**CERTIFICATE OF APPROPRIATENESS**

**Property:** 8111 De Leon St, Lot 10, Block 62, Glenbrook Valley Section 11 Subdivision. The property includes a historic 3,246 square foot one-story single family residence situated on a 12,065 square foot interior lot.

**Proposal:** Alteration—Applicant proposes two changes to the exterior of the home:

**Current Photograph**

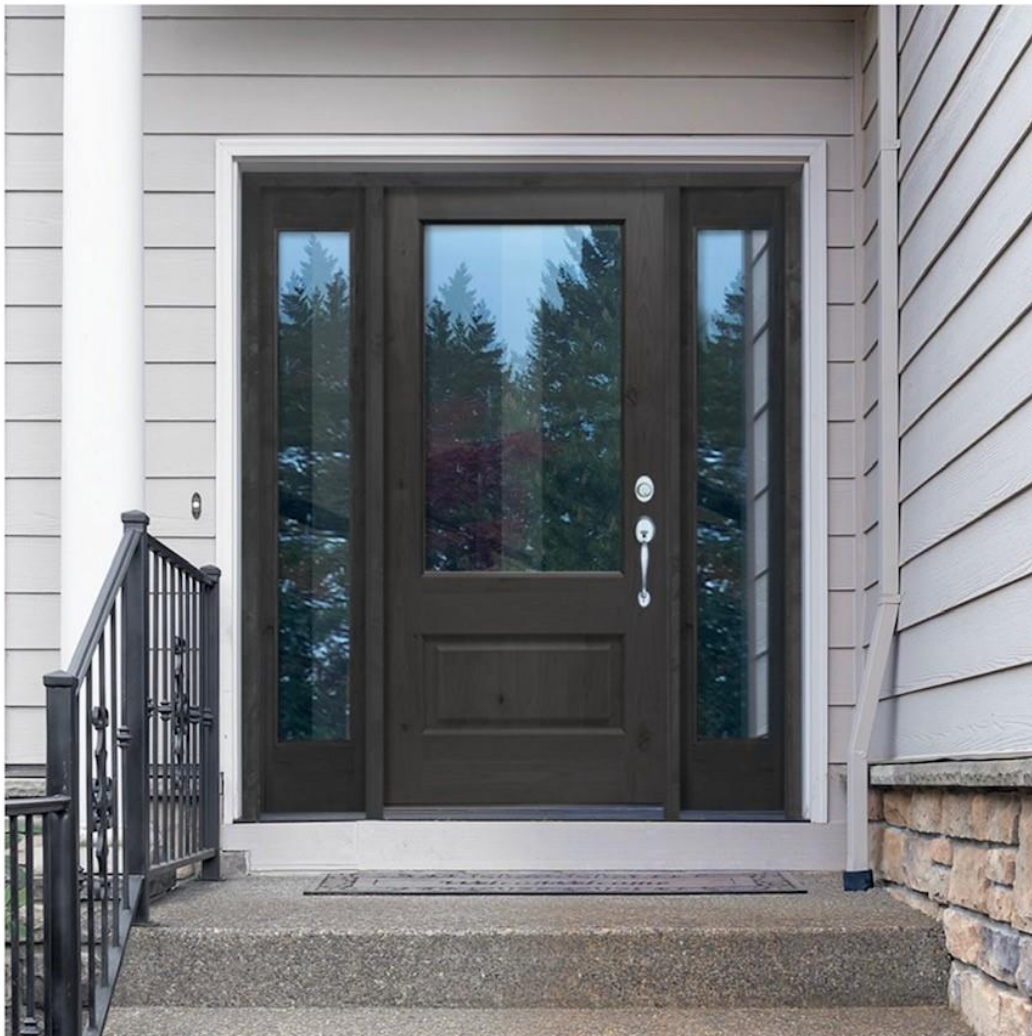
| <input type="checkbox"/>            | <input checked="" type="checkbox"/> | <input type="checkbox"/>            | (1) The proposed activity must retain and preserve the historical character of the property;<br><i>Painting unpainted original brick is not preserving the historical character of a Traditional Ranch 1960 historical structure.</i>                                                                                                                                                                                                                             |
| <input type="checkbox"/>            | <input checked="" type="checkbox"/> | <input type="checkbox"/>            | (3) The proposed activity must recognize the building, structure, object or site as a product of its own time and avoid alterations that seek to create an earlier or later appearance;<br><i>Painting unpainted original brick is actively changing the historical character of a Traditional Ranch 1960 historical structure to a later appearance.</i>                                                                                                         |
| <input type="checkbox"/>            | <input checked="" type="checkbox"/> | <input type="checkbox"/>            | (4) The proposed activity must preserve the distinguishing qualities or character of the building, structure, object or site and its environment;<br><i>Painting unpainted original brick is not preserving the historical character of a Traditional Ranch 1960 historical structure.</i>                                                                                                                                                                        |
| <input type="checkbox"/>            | <input checked="" type="checkbox"/> | <input type="checkbox"/>            | (5) The proposed activity must maintain or replicate distinctive stylistic exterior features or examples of skilled craftsmanship that characterize the building, structure, object or site;<br><i>Painting unpainted original brick is not preserving the historical character of a Traditional Ranch 1960 historical structure.</i>                                                                                                                             |
| <input type="checkbox"/>            | <input checked="" type="checkbox"/> | <input type="checkbox"/>            | (10) The proposed alteration or addition must be compatible with the massing, size, scale material and character of the property and the context area; and<br><i>Painting unpainted original brick is not preserving the historical character of a Traditional Ranch 1960 historical structure.</i>                                                                                                                                                               |

**Recommendation:** **Partial Approval:** Staff recommends approval of the front door and two side lites; staff does not recommend approval on the painting of unpainted masonry.
